BLUE SPRINGS MEADOW
EL PASO COUNTY
CONSTRUCTION DRAWINGS
AUGUST 2026

EPC STORMWATER REVIEW COMMENTS
IN ORANGE BOXES WITH BLACK TEXT

BLUE SPRINGS MEADOW
CONSTRUCTION DRAWINGS
COVER SHEET

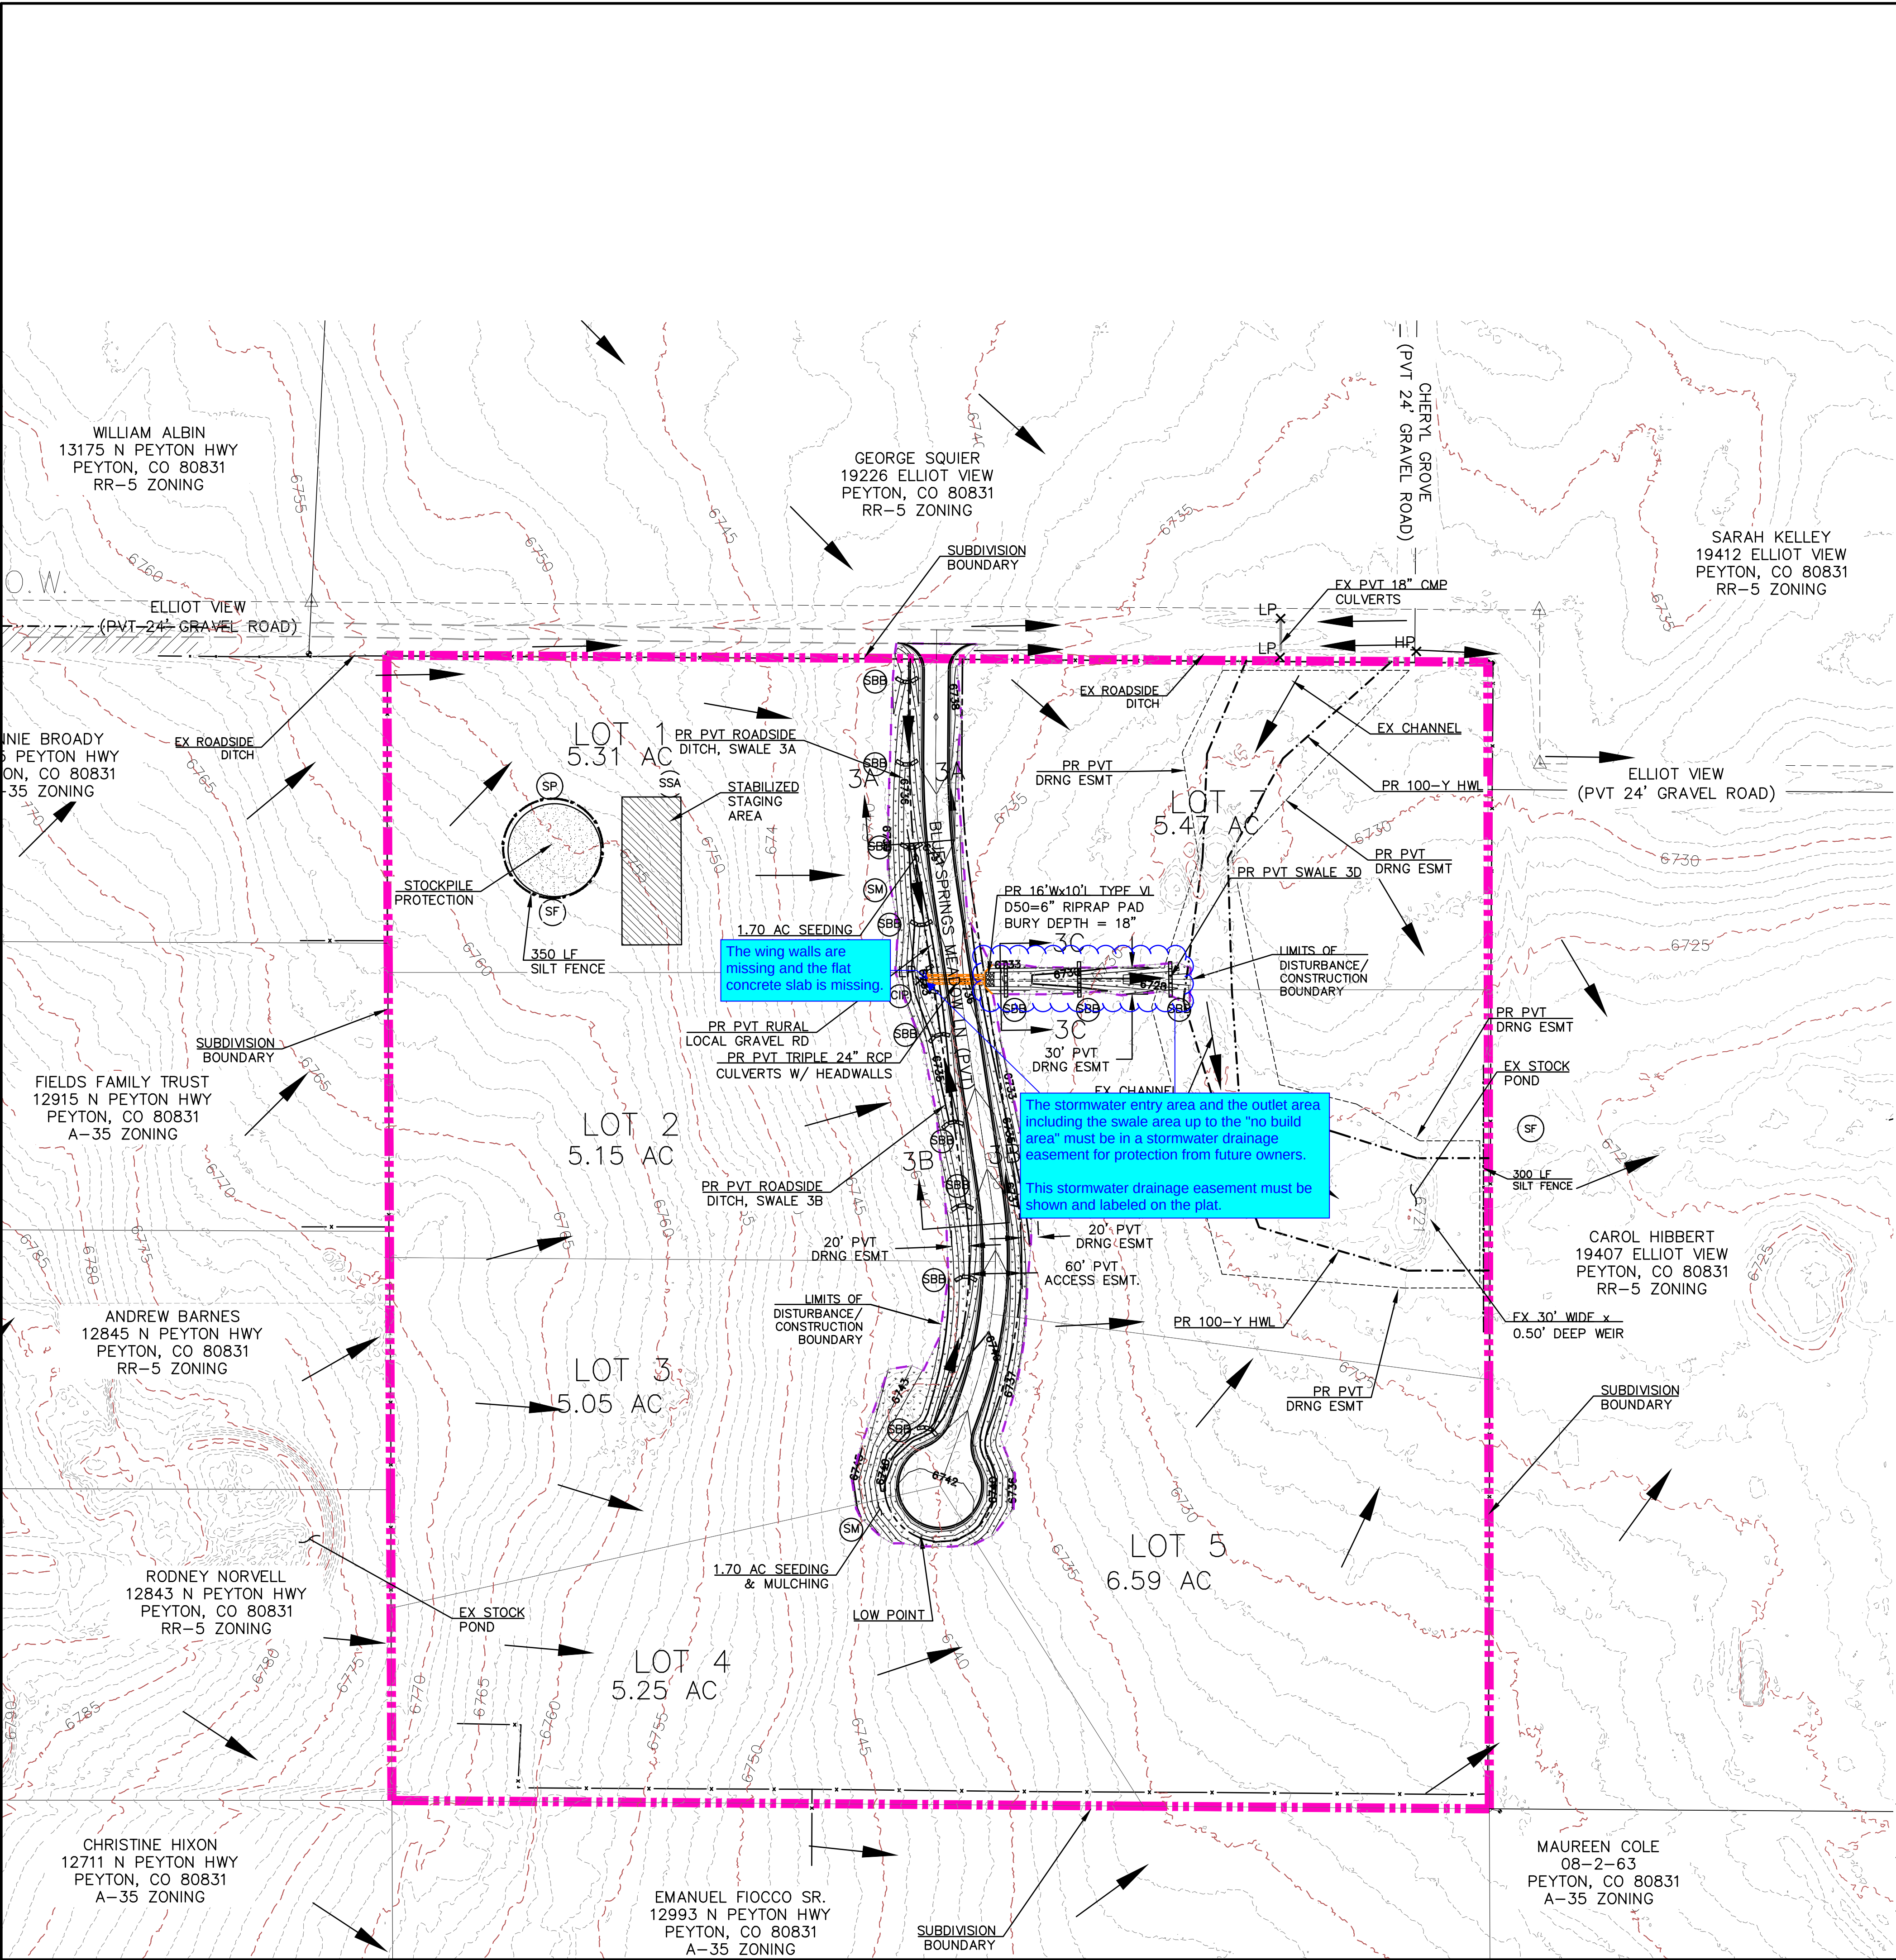
Is this accurate? You already have a GEC Plan.
